From: Moran, Robin [moran.rob@epa.gov]
Sent: 10/31/2018 6:51:05 PM
To: Charmley, William [charmley.william@epa.gov]; Bolon, Kevin [Bolon.Kevin@epa.gov]; Olechiw, Michael [olechiw.michael@epa.gov]; Cherry, Jeff [Cherry.Jeff@epa.gov]; Sherwood, Todd [sherwood.todd@epa.gov]
Subject: BorgWarner comments -- to have handy during meeting
Attachments: BorgWarner.pdf

“We recommend an approach different from those proposed in the NPRM:

Figure 3

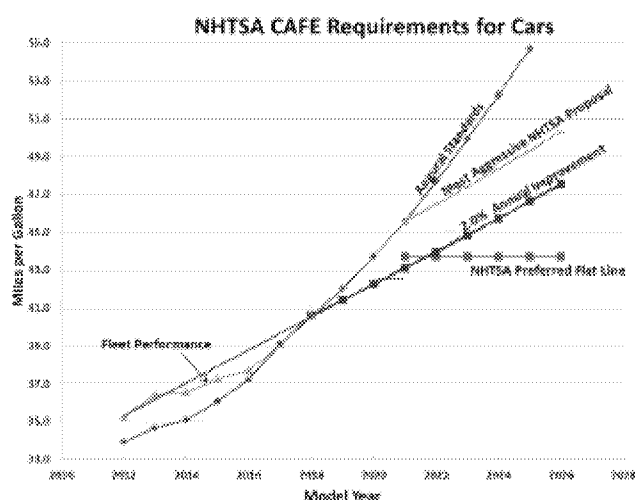
- ☐ **Beginning in model year (MY) 2018, standards should be reset to the levels the industry actually achieved.**
- ☐ **For MY 2018 and beyond, succeeding model year targets should be set with an annual rate of improvement defined by the slope of improvement the industry has achieved over the last six years.”**
[graph below says this = 2%/year]

Figure 3 (left) shows the past CAFE performance of the passenger car fleet with projections based on the range of options presented in the NPRM. A line representing a 2.0% annual improvement is also shown, which matches the rate of improvement between 2012 and 2018.
